**RE: Generations at West Mesa
5710 Avalon Rd NW
Grading and Drainage Plan
Engineer's Stamp Date: 04/11/18
Hydrology File: K11D084**

Based upon the information provided in your resubmittal received 04/17/2018, the Grading and Drainage Plan is approved for Building Permit and Grading Permit.

Cypress Civil Development has compiled the following responses to the comment letter received from City of Albuquerque Hydrology Department for the above mentioned project. The responses are listed by heading below:

PROJECT OVERVIEW PLAN

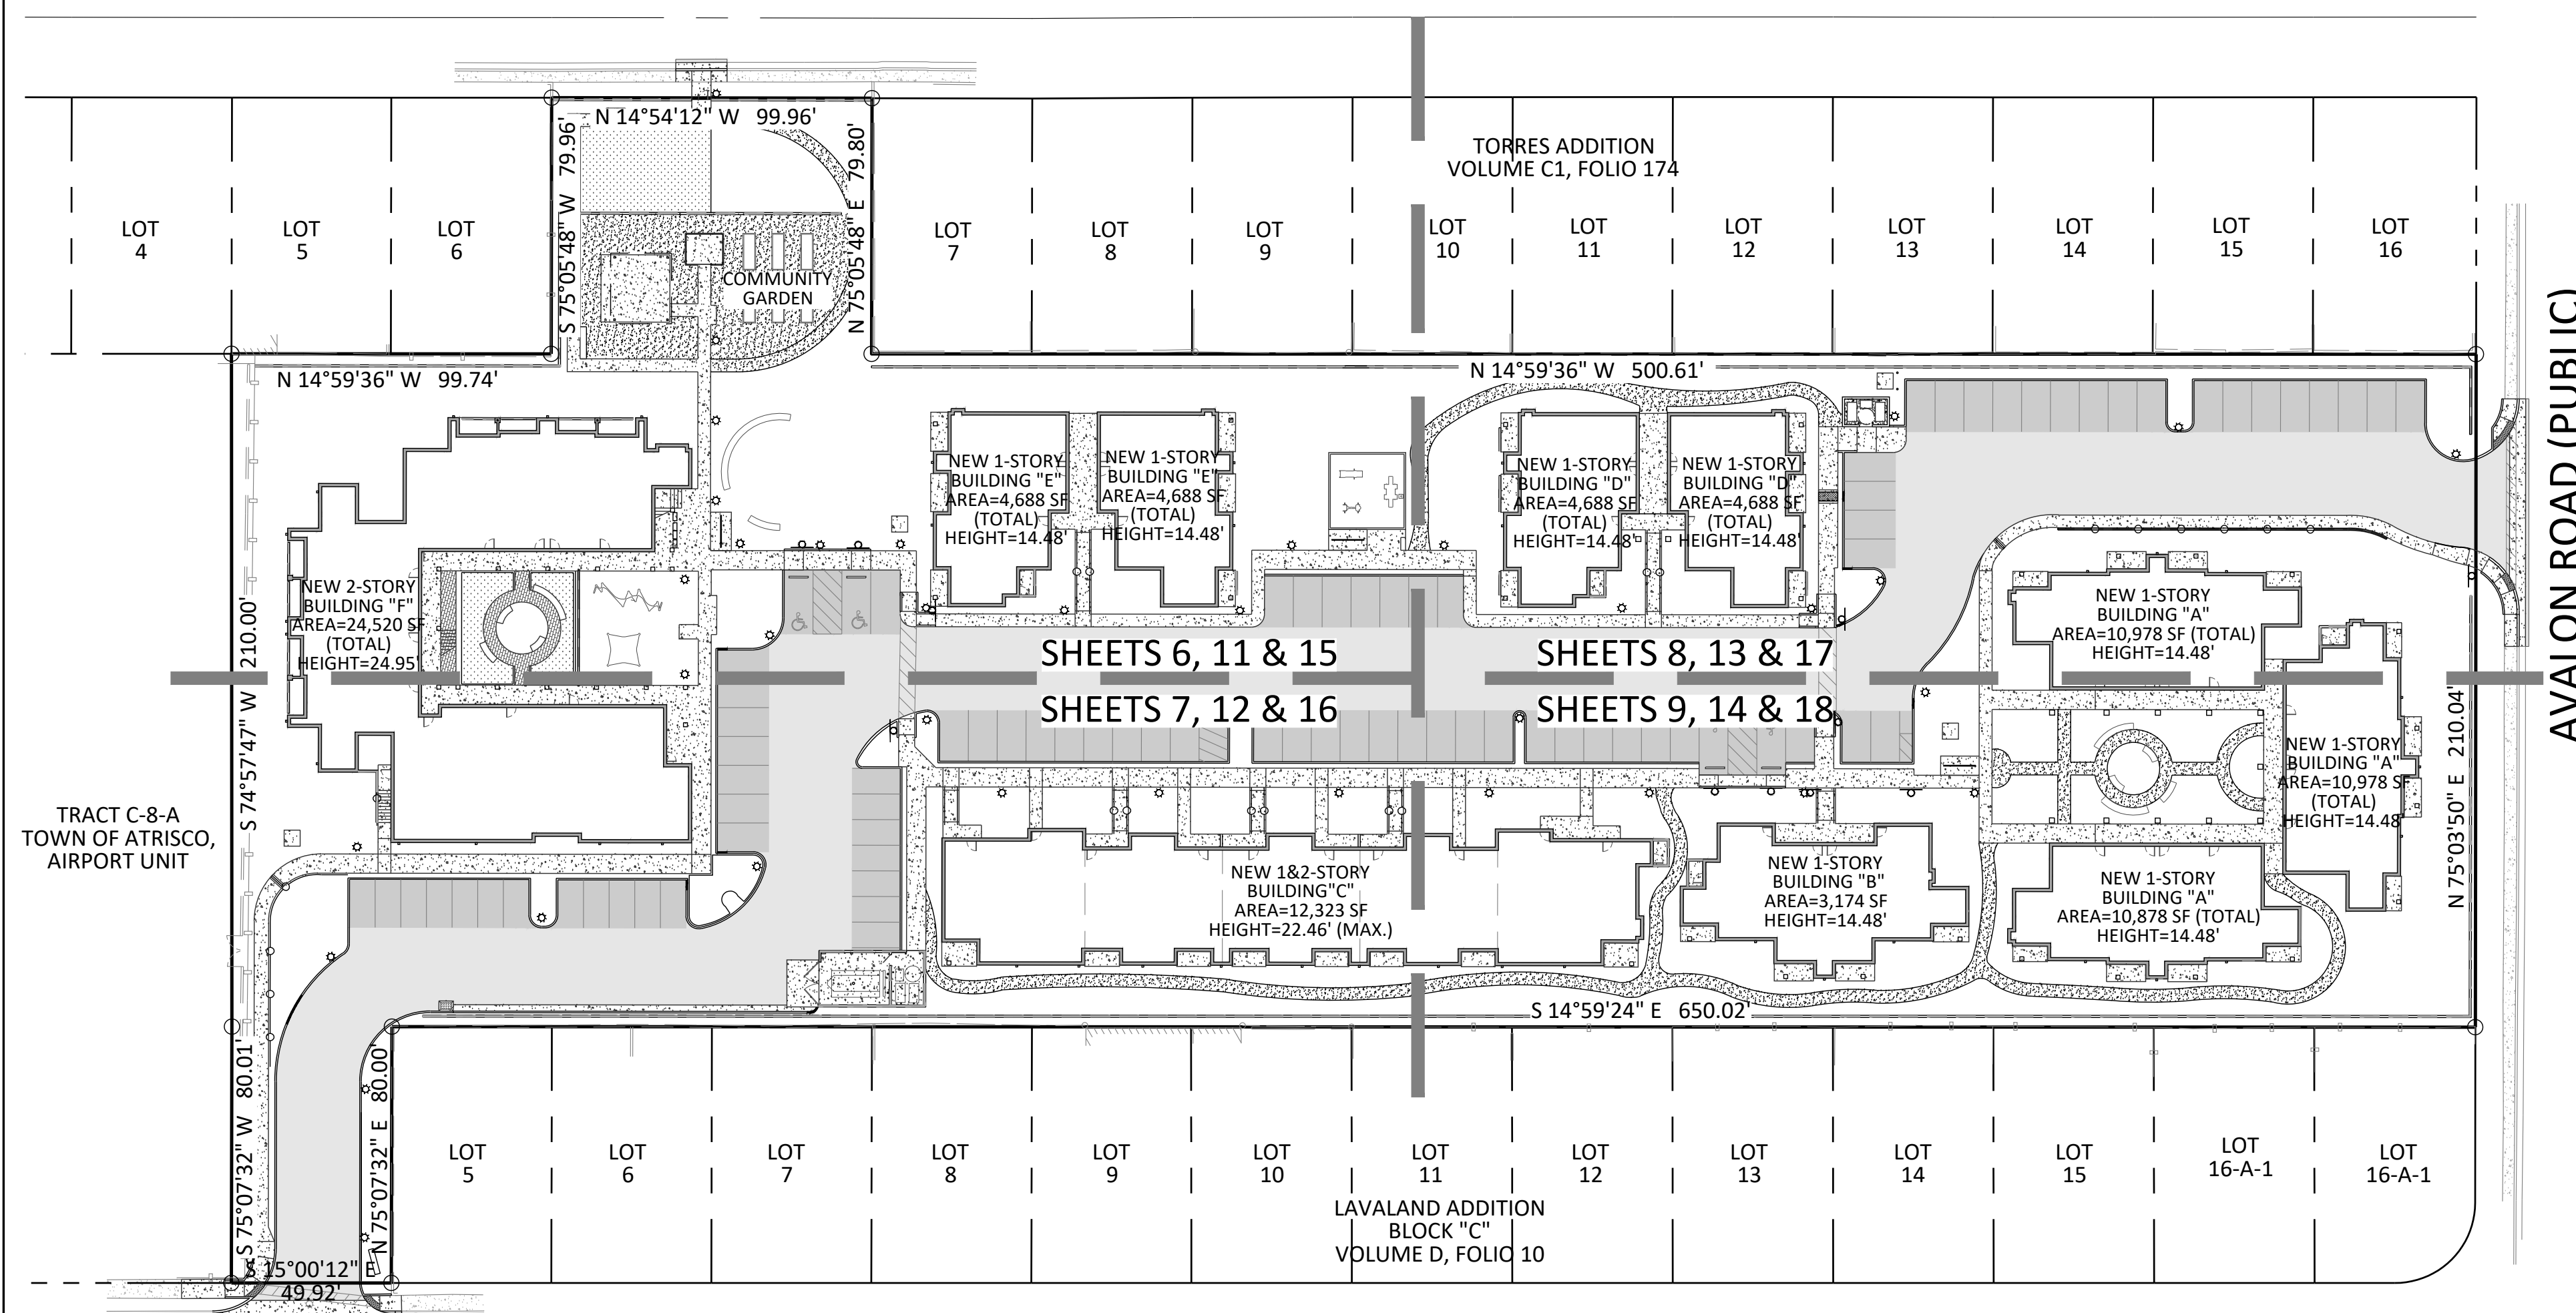
Comment 5 – Complied. The FIRM Map and flood plain note with effective date is now provided on sheet C001.

EXISTING WATERSHED
MAP

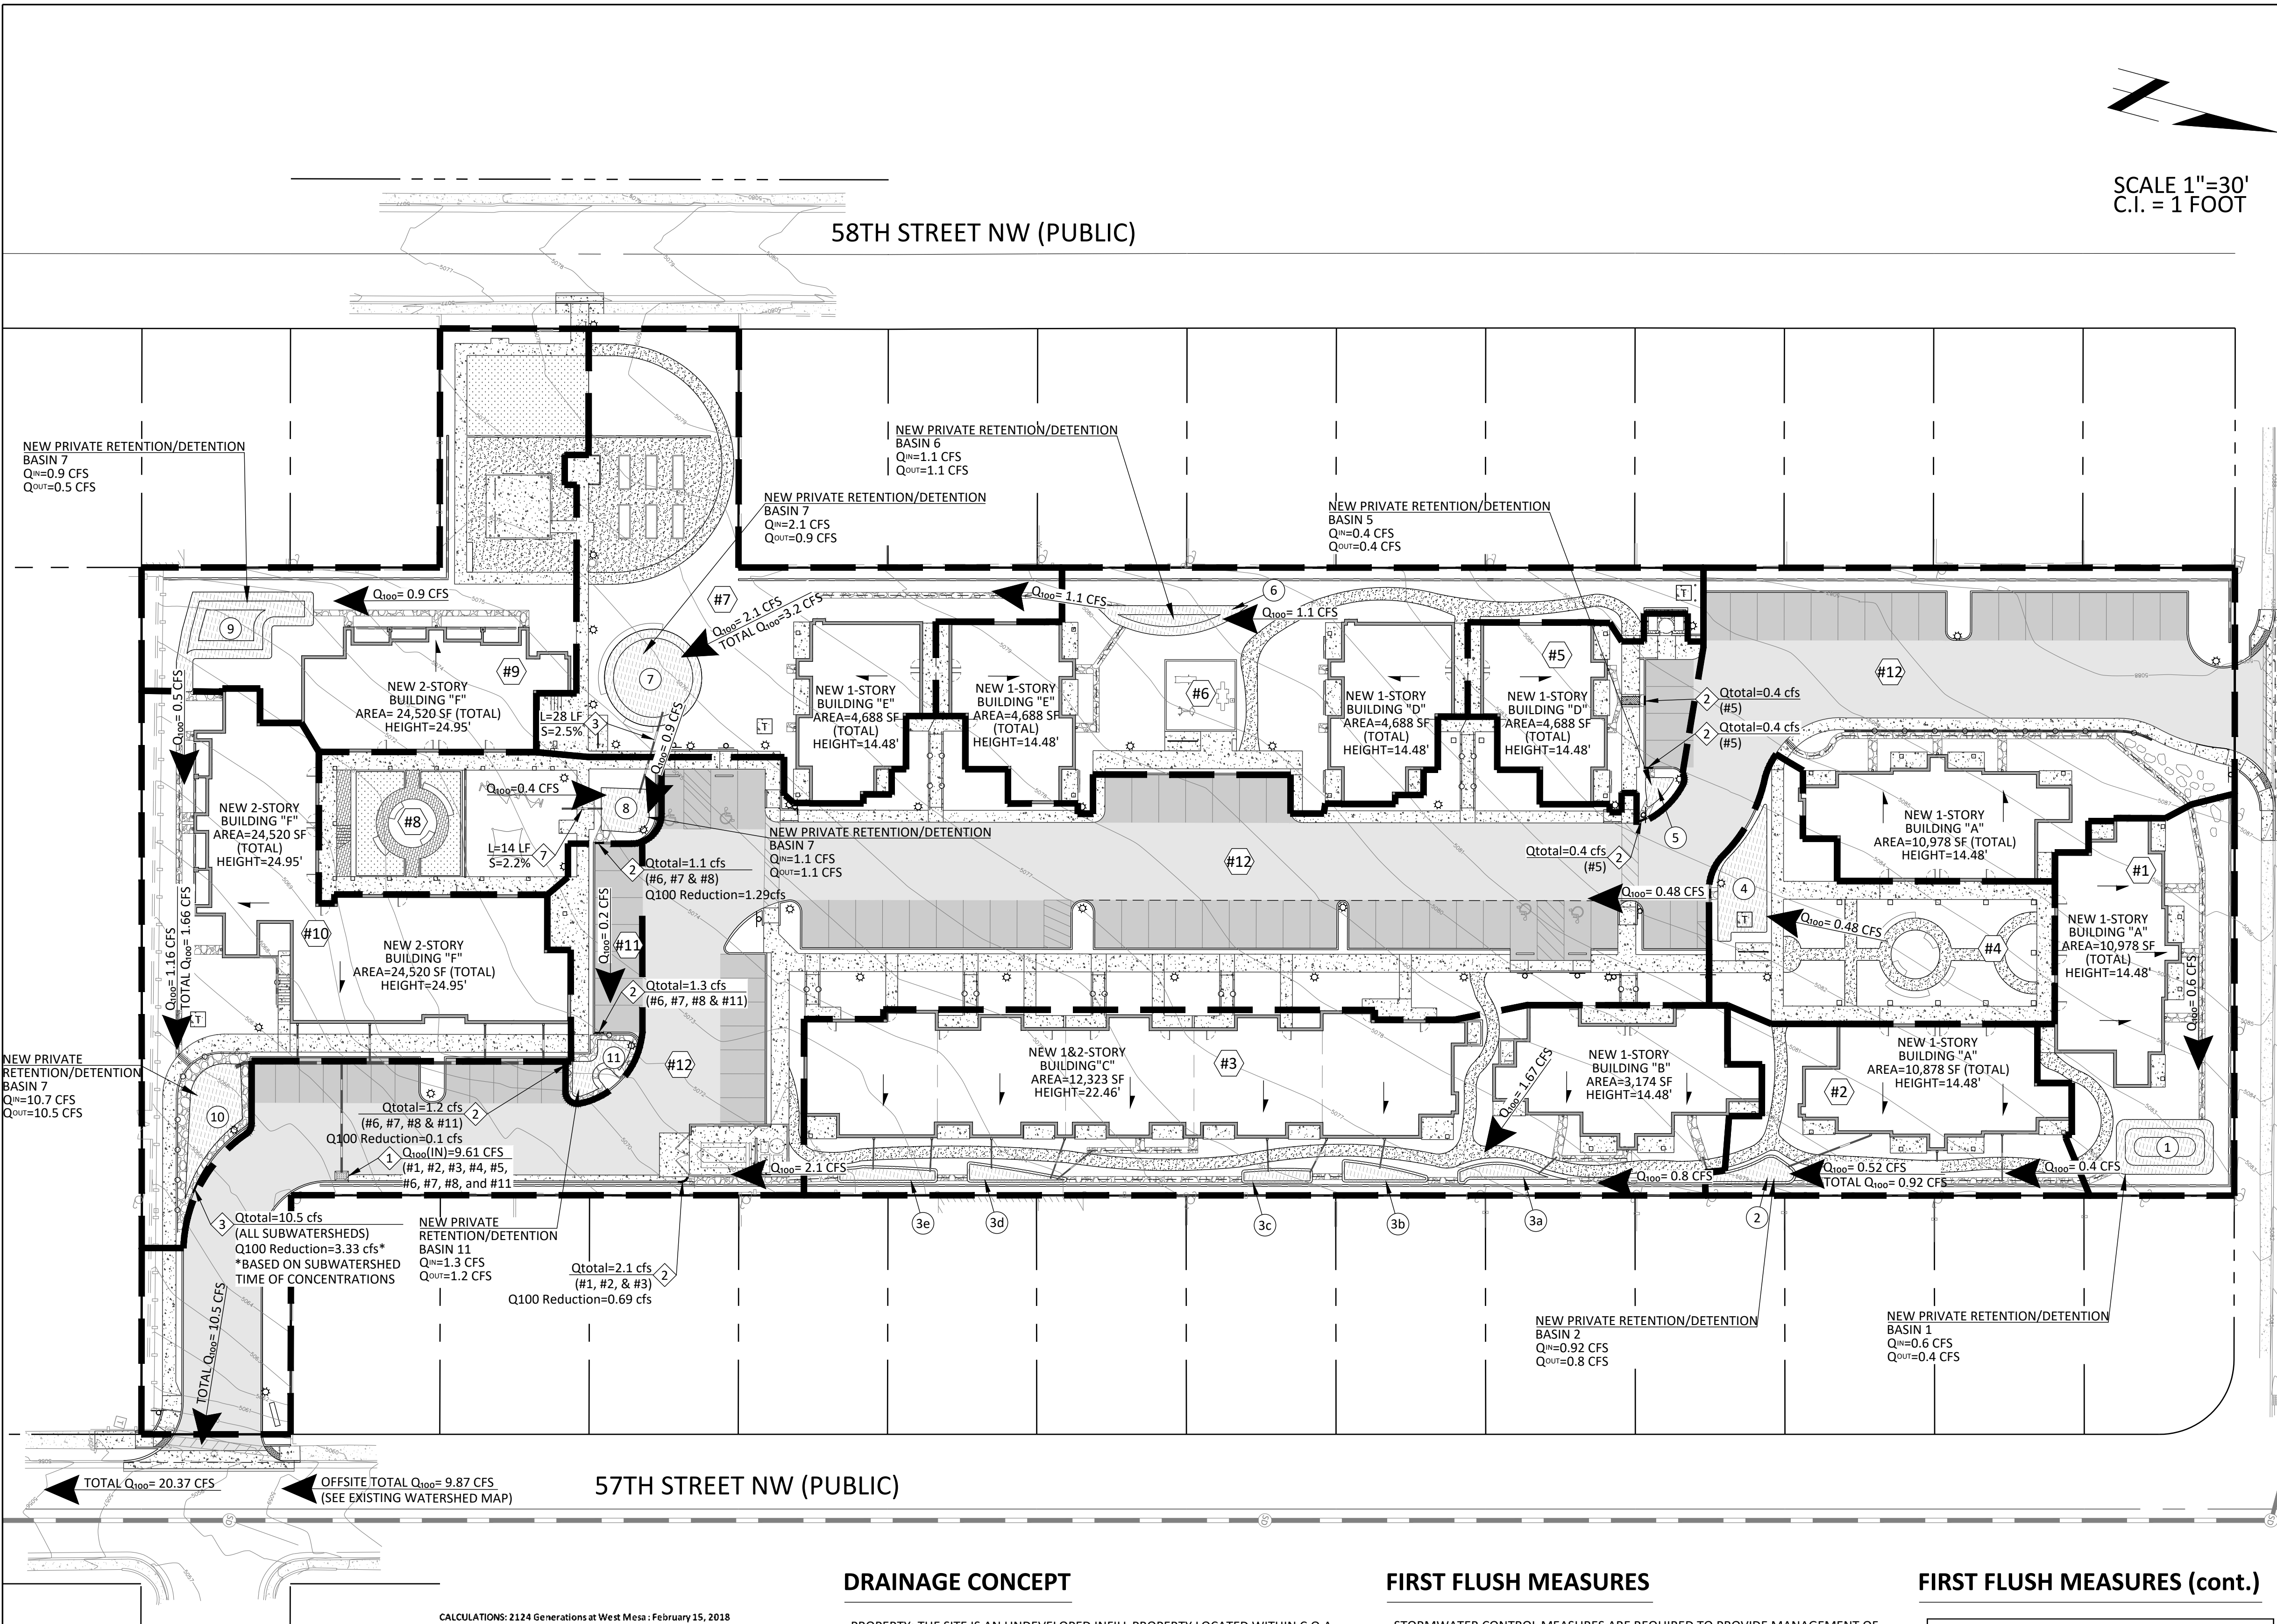
Comment 4 – Complied. The Existing and Proposed watersheds are now included in the plan set.

Comment 11 – Complied. An Existing Conditions section is now provided on the Existing Watershed Map.

Comment 12 – Complied. The existing drainage calculations now account for the runoff that is captured by the existing storm drain inlets. The inlet

C005

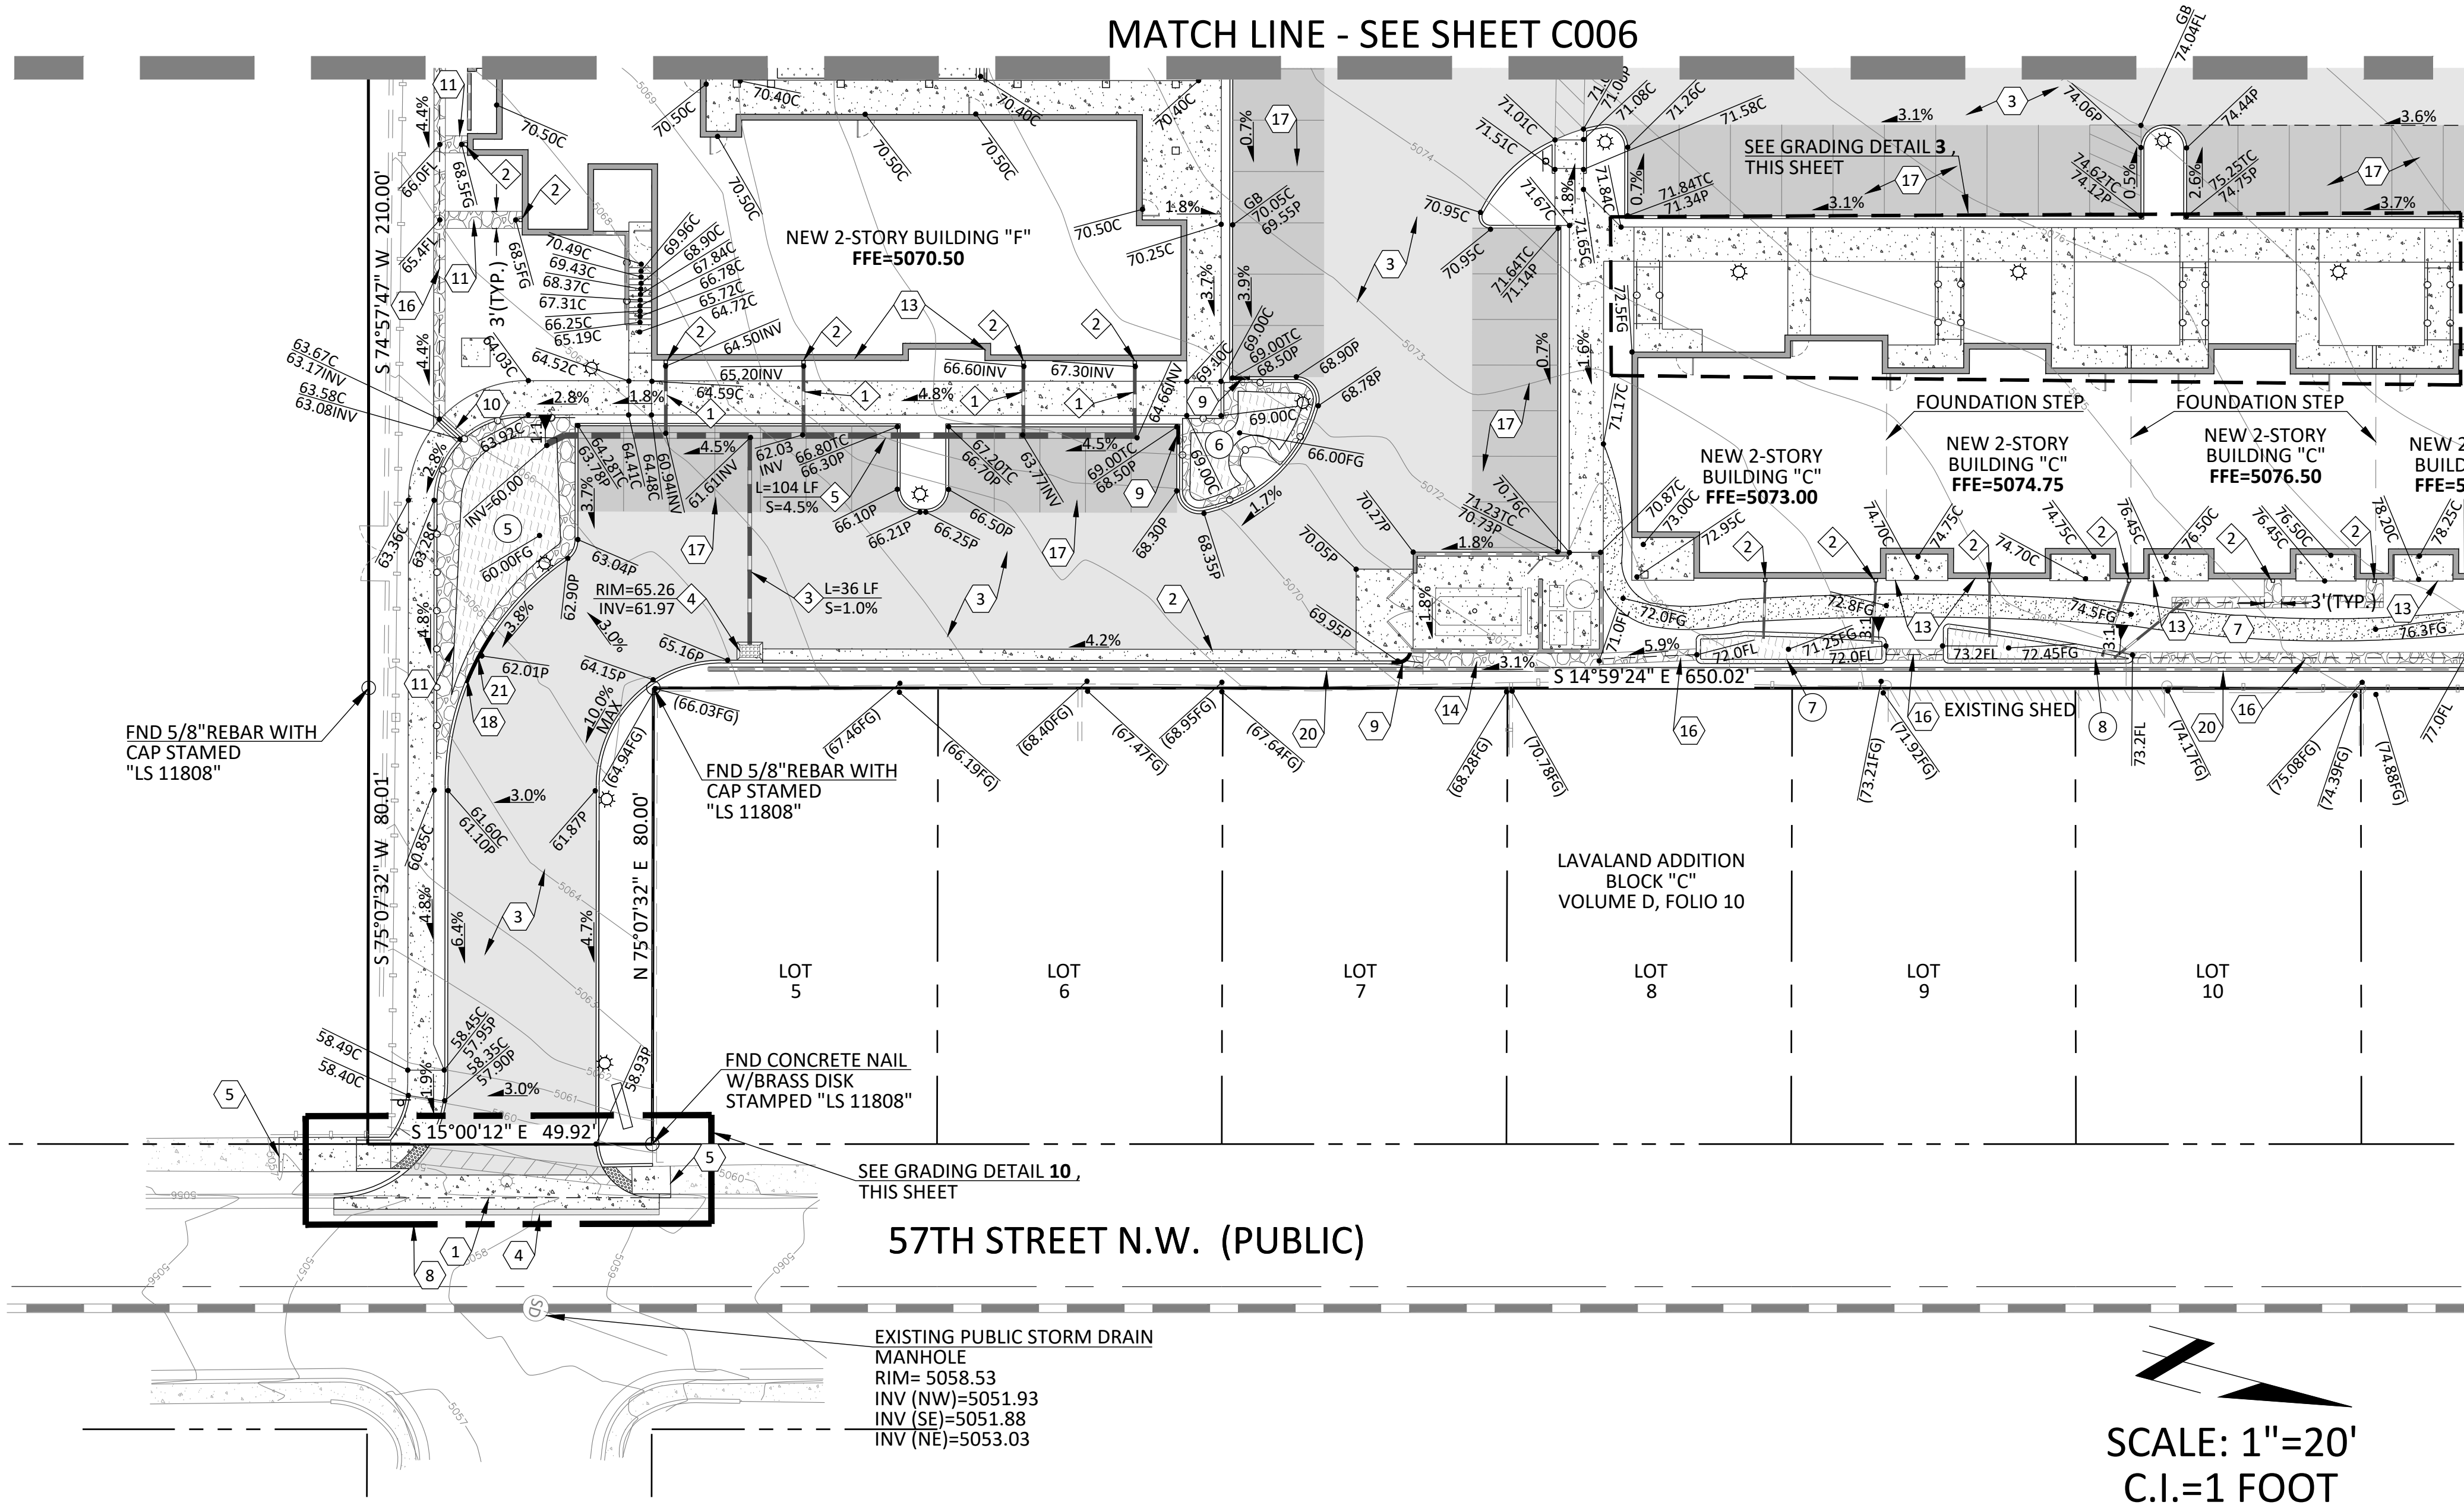
Comment 7 – Complied. The Drainage Concept and First Flush Measures is now provided on the proposed watershed map.

Comment 16 – Complied. Weir calculations are now provided for the proposed curb openings (3' and 10' wide). Each curb opening is now called out on the proposed watershed map with the associated Q value that is conveyed through each curb opening.
